Access Compliance Report

Public Rights-of-Way

Intersection ID: 10584	Main Street: COXE_AV	Cross Street: S_TURNER_AV	Location: SE
ADA ID: 77AA05309B8C	Ramp Type: BlendTrans1	Initial Pass/Fail: Fail	Overall Compliance: No
		Severity Score: 25

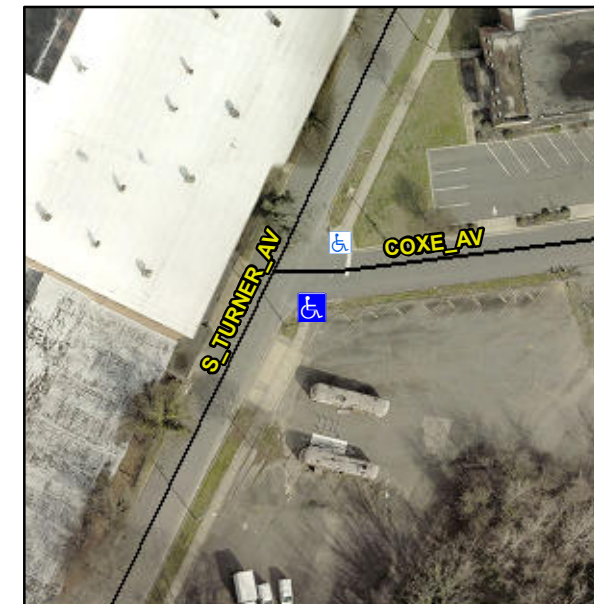
Not Found, R304.5.3

Compliance	Description	Data	Compliance	Description	Data
N/A	Ramp Length (in)	74.0	Yes	BlendTrans Slope (%)	4.2
Yes	Ramp Width (in)	57.0	No	BlendTrans XSlope (%)	7.8
N/A	Flare Type LT	N/A	N/A	Flare Type RT	N/A
N/A	Flare Slope LT (%)	N/A	N/A	Flare Slope RT (%)	N/A
N/A	Flare Traversable LT?	N/A	N/A	Flare Traversable RT?	N/A
N/A	Landing Length (in)	N/A	N/A	DWS Provided?	N/A
N/A	Landing Width (in)	N/A	N/A	DWS Contrast?	N/A
N/A	Landing Slope (%)	N/A	N/A	DWS Length (in)	N/A
N/A	Landing X Slope (%)	N/A	N/A	DWS Full Width?	N/A
N/A	Landing Curb? (Y/N)	N/A	N/A	DWS Offset (in)	N/A
N/A	Shared Landing?	N/A			
N/A	Gutter Ponding?	N/A	N/A	Gutter Slope (%)	N/A
N/A	Gutter Lip Ht (in)	N/A	N/A	Gutter X Slope (%)	N/A
N/A	Painted X Walk1?	No	N/A	Painted X Walk2?	N/A
	X Walk 1 Direction	To NE		X Walk 2 Direction	N/A
	X Walk 1 Width (in)	N/A		X Walk 2 Width (in)	N/A
	X Walk 1 Slope (%)	5.4		X Walk 2 Slope (%)	N/A
	X Walk 1 X Slope (%)	4.4		X Walk 2 X Slope (%)	N/A

Remove & Replace Curb Ramp With Two New Directional Ramps or Equivalent.
